**Rules and
Regulations for
the Classification
of Ships, July 2007**

Notice No. 4

Issue date: April 2008

This Notice contains amendments within the following Sections of the *Rules and Regulations for the Classification of Ships, July 2007*. The amendments are effective on the dates shown:

Fig. 4.6.1 Location of windows and side scuttles

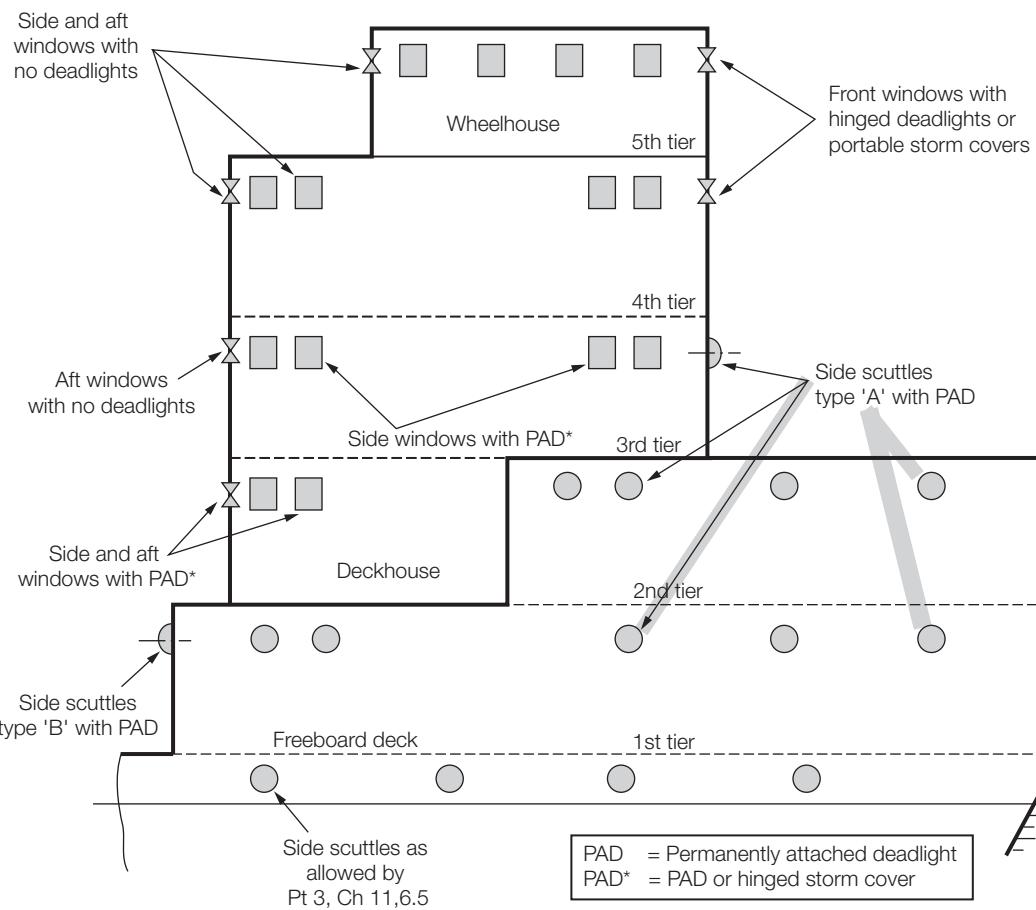
Table 4.6.1 Design pressure head, H_d , on windows
